56' Collector & Local Street with Curb

CONSTRUCTION STANDARDS

~~56' COLLECTOR STREET CROSS SECTION WITH CURB~~

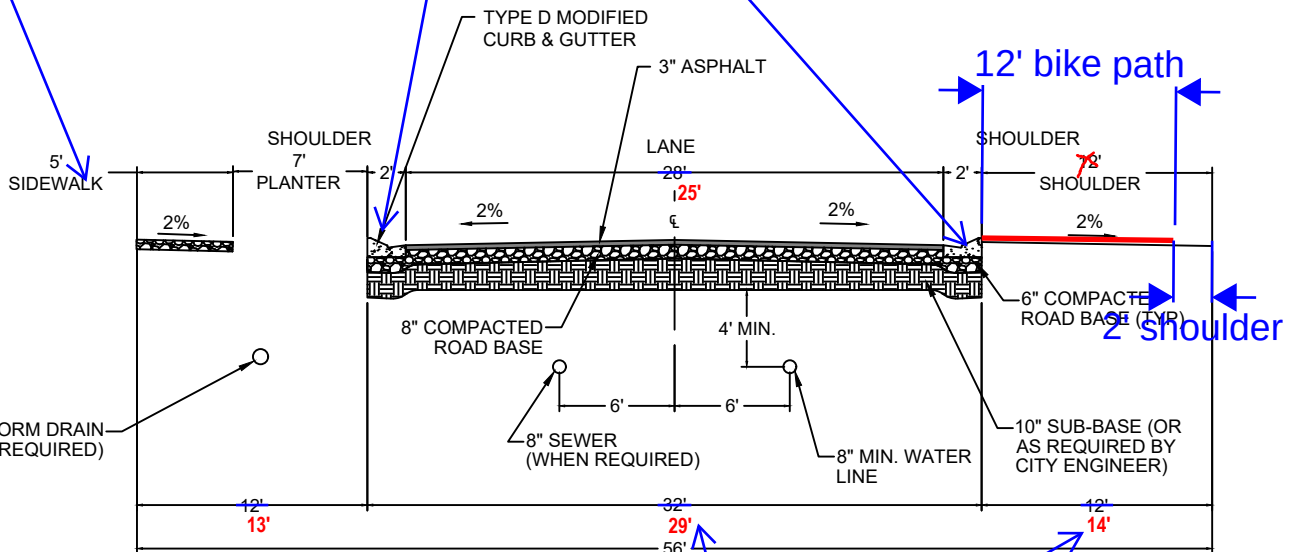
still want sidewalk?

high back or modified?

12' bike path

2' shoulder

should probably center the road within the ROW
